McCLENNY ACRES MITIGATION PLAN

Wayne County, NC
NCDEQ Contract No. 7423
DMS ID No. 100038

Re: NCIRT Review and USACE Approval of the McClenny Acres Mitigation Plan; SAW-2018-02042;
NCDMS Project # 100038

Subject: Final Mitigation Plan
McClenny Acres Mitigation Project, Wayne County
Neuse River Basin HUC 03020201
USACE AID# SAW-2018-02042
DMS Project ID No. 1000382 / DEQ Contract # 7423

Figure 6 Credit Calculations Map
 McClenny Acres Mitigation Site
 Neuse River Basin 03020201

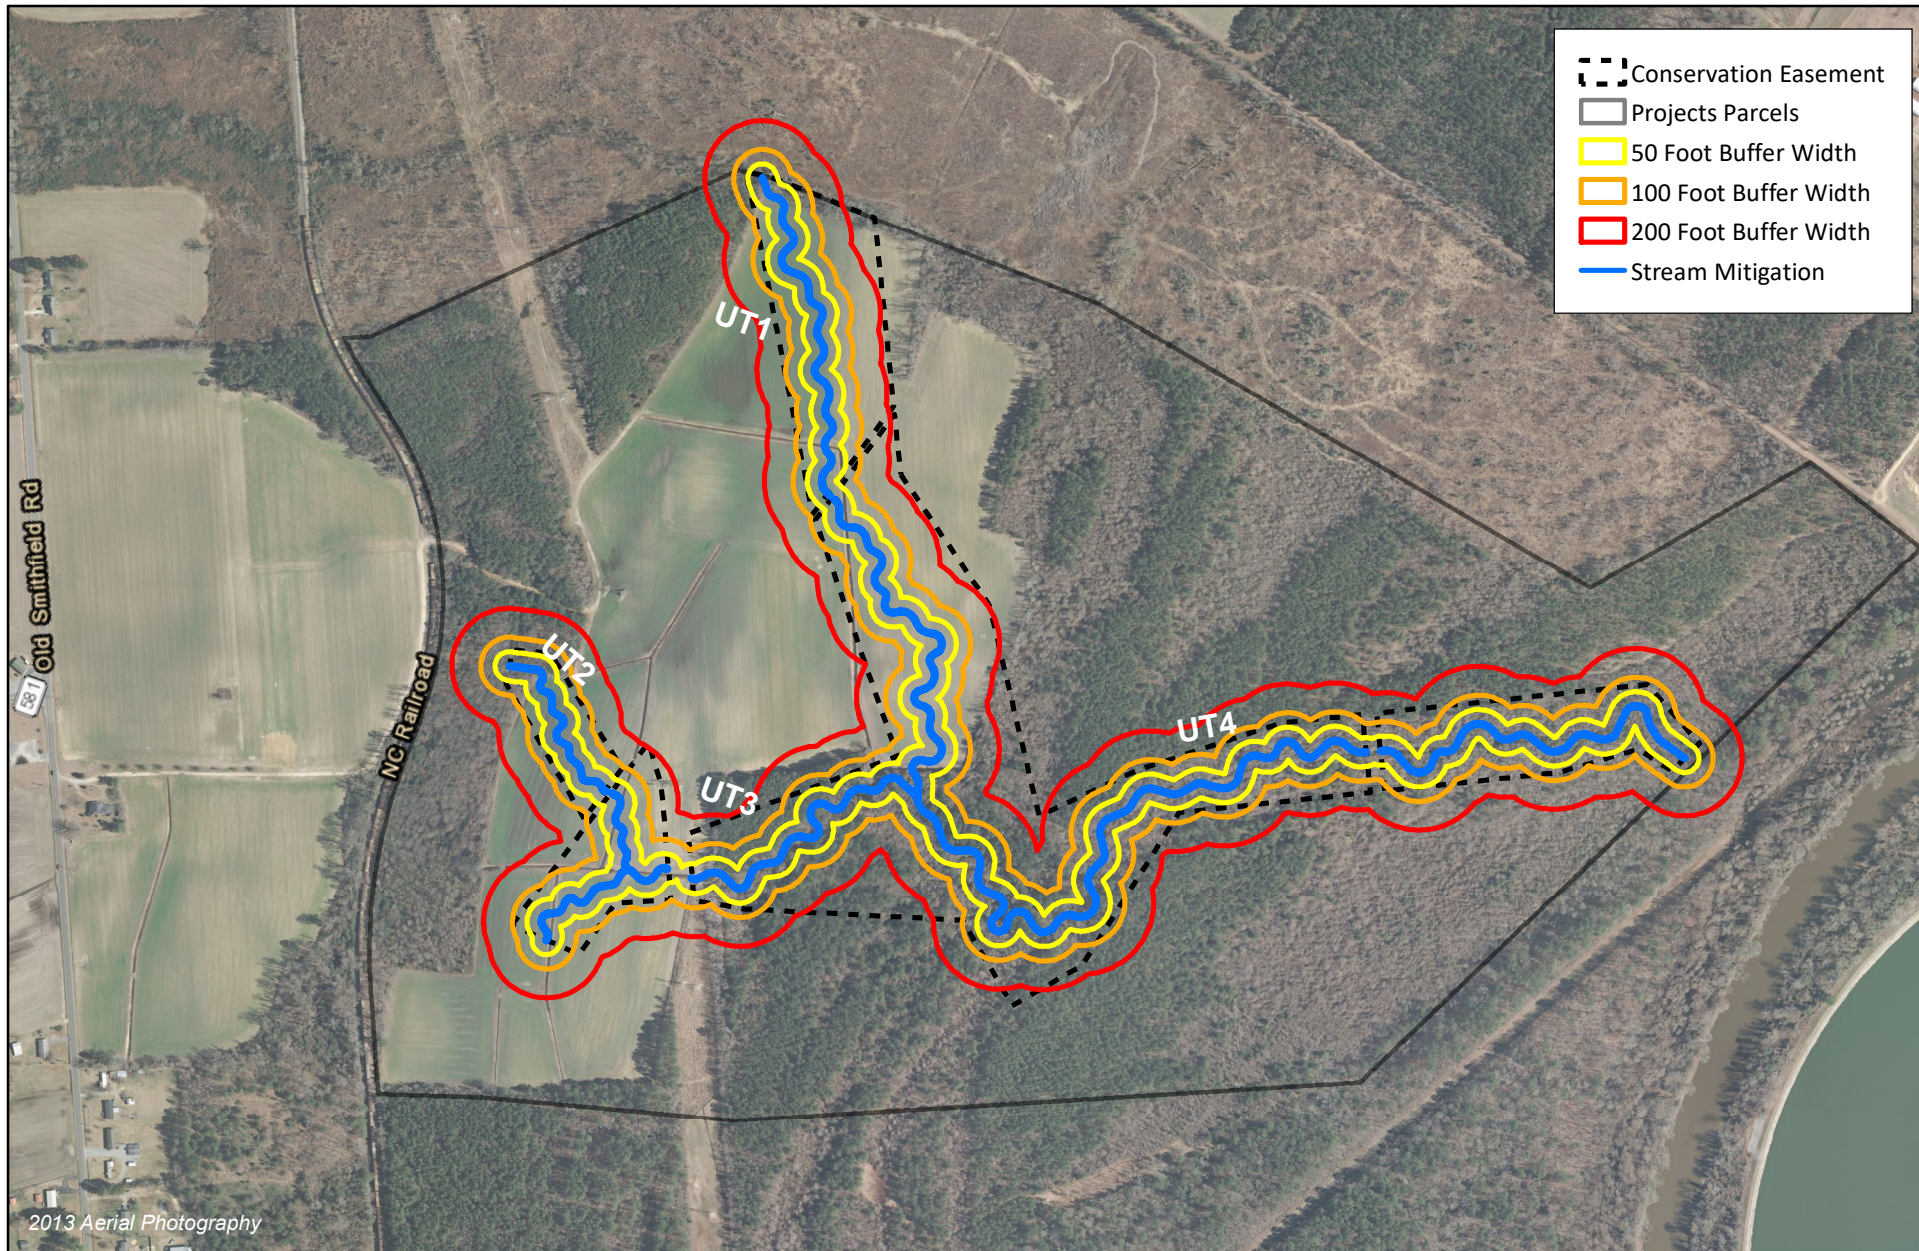
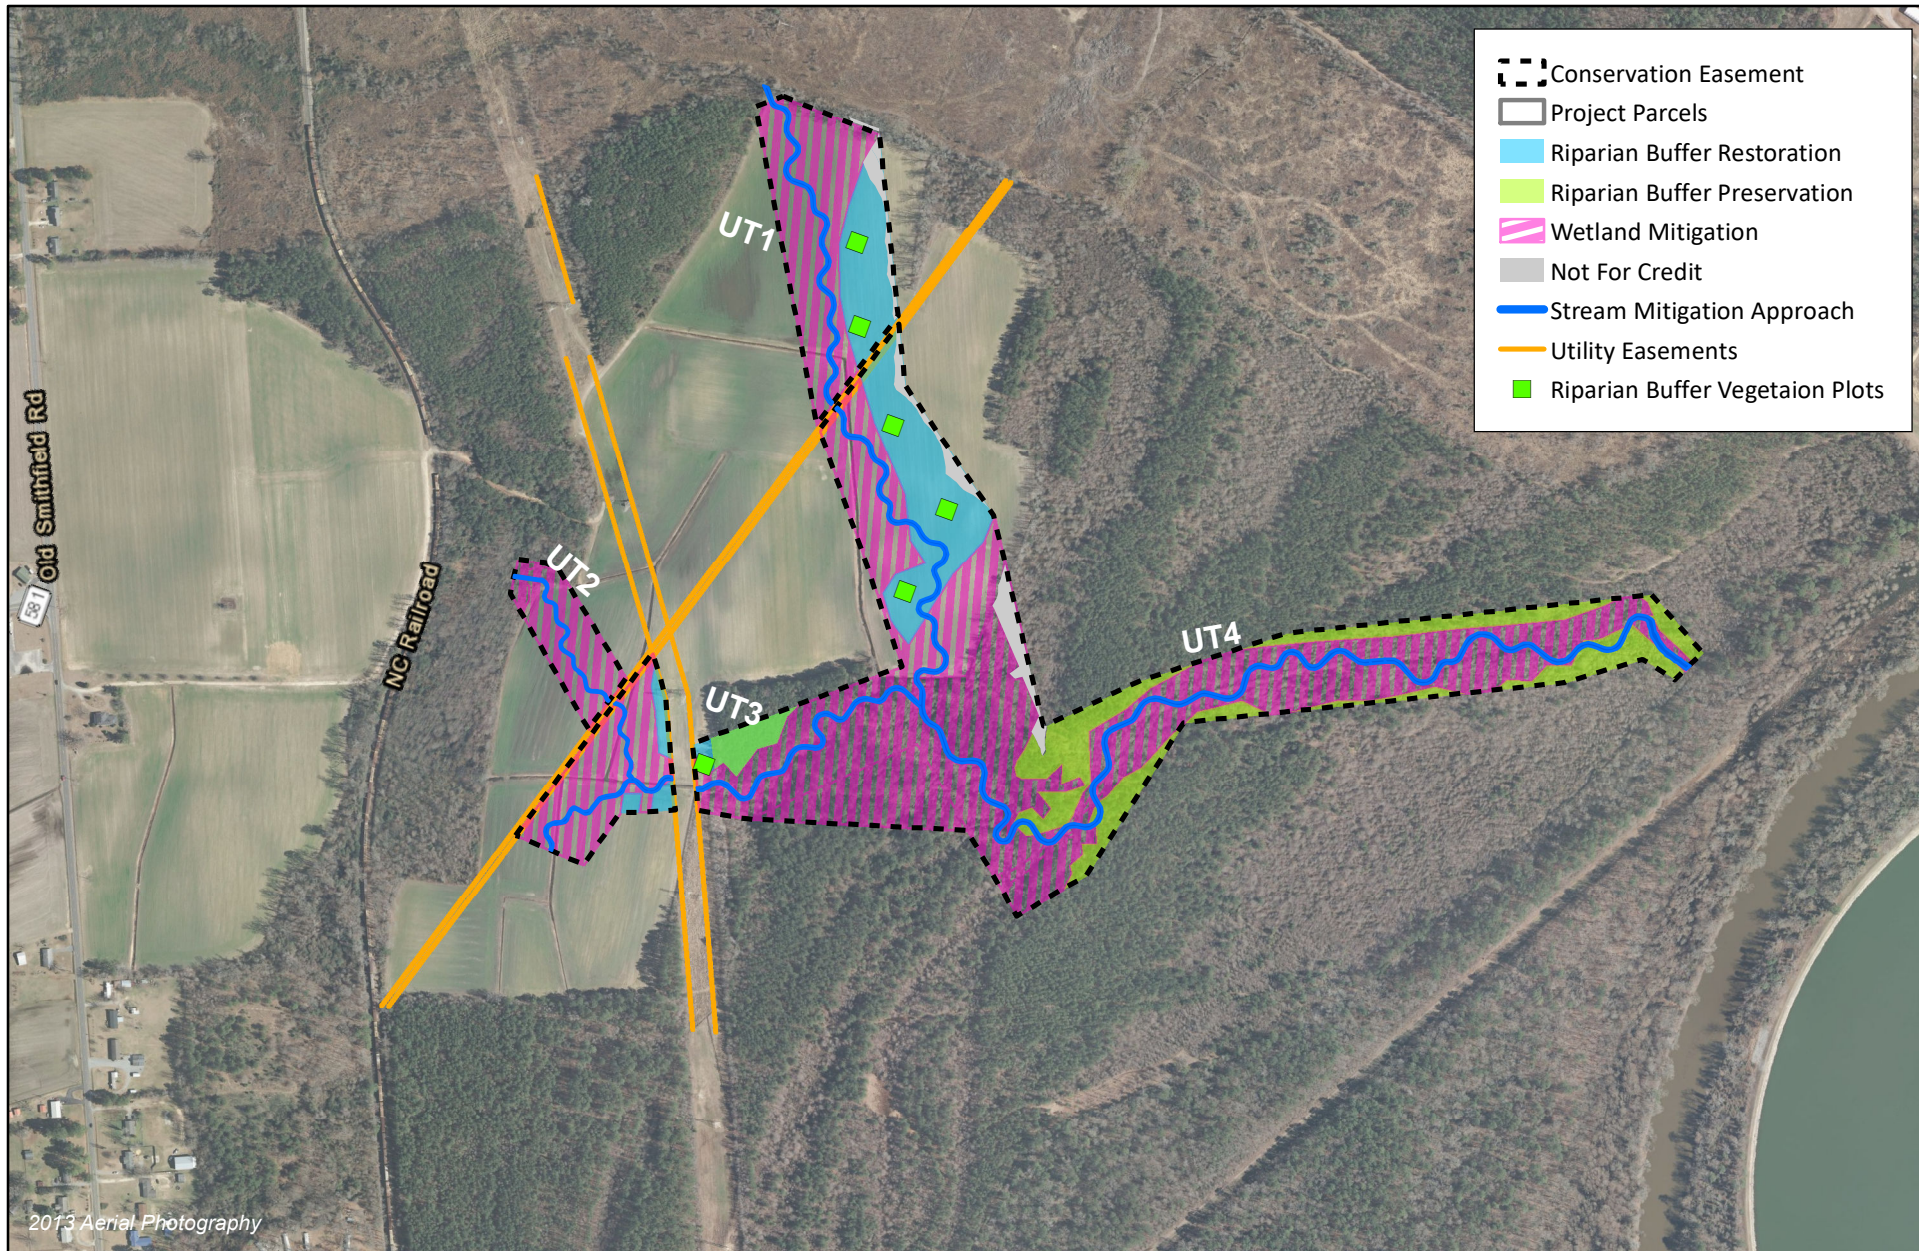
- 8. An area shown as buffer credits in Figures 6-9 along UT1 before the confluence with UT3 is shown as wetland credits in Figure 10 of the Stream Mitigation Plan. Please correct.*

Figure 9 Nutrient Offset Zones Map
McClenny Acres Mitigation Site
Neuse River Basin 03020201

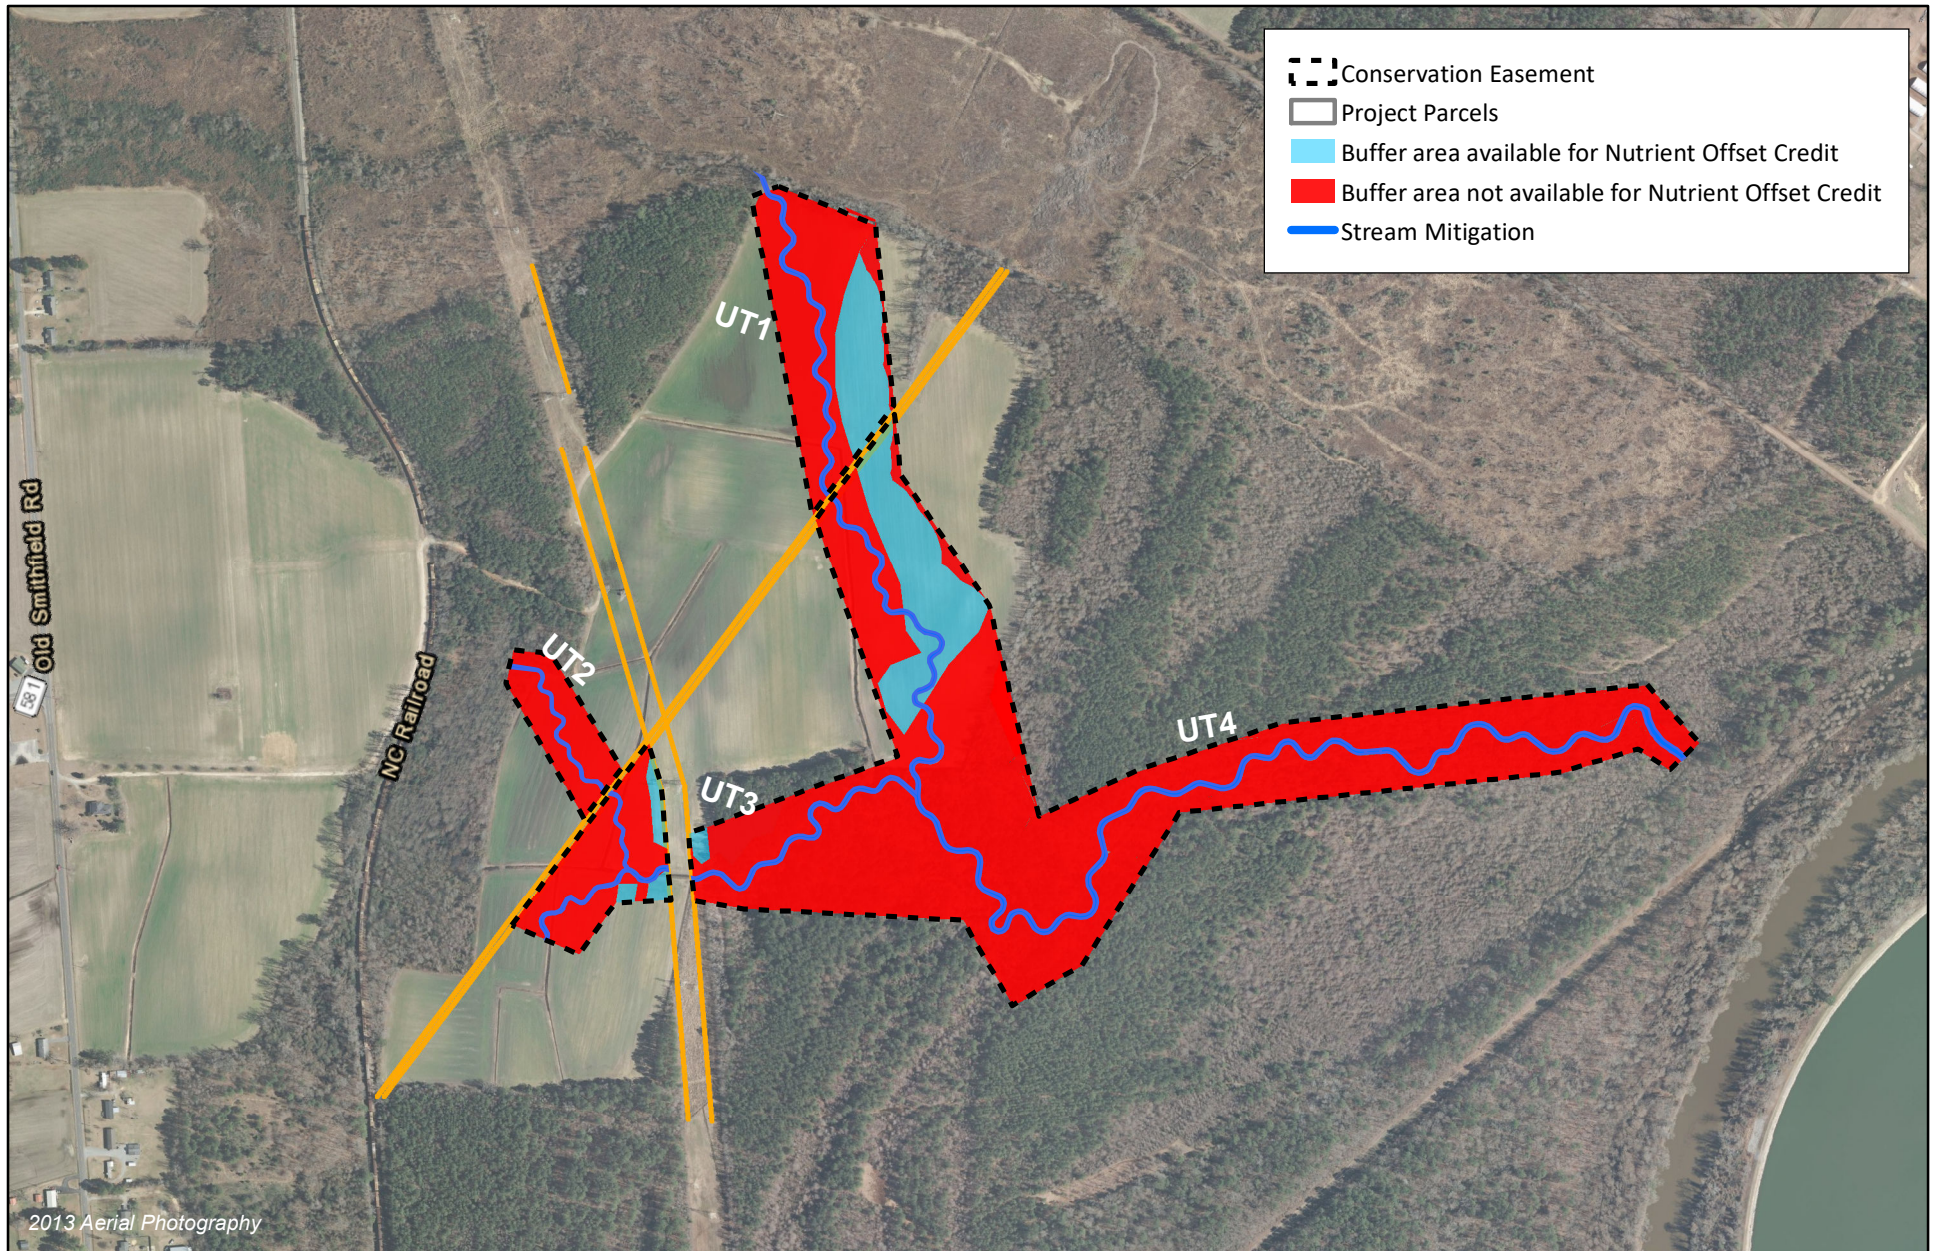
- 9. Figure 6b is confusing. It's labeled as "Credit Calculations Map" just as Figure 6 is labeled. But it includes different mitigation types (buffer & wetland). This map should be removed from the plan, as DWR does not authorize wetland mitigation to be converted into buffer credit or nutrient credit on this site. DWR suggests relabeling this map "Nutrient Offset potential" and using this to show where nutrient offset credits are viable for comparison to Table 8b.*

This figure has been deleted, Figure 9 is the nutrient offset potential map showing what areas can be converted, upon written approval from DWR, between buffer mitigation and nutrient offset credits. Wetland mitigation that fails to meet performance standards is not being proposed as buffer mitigation credit now.
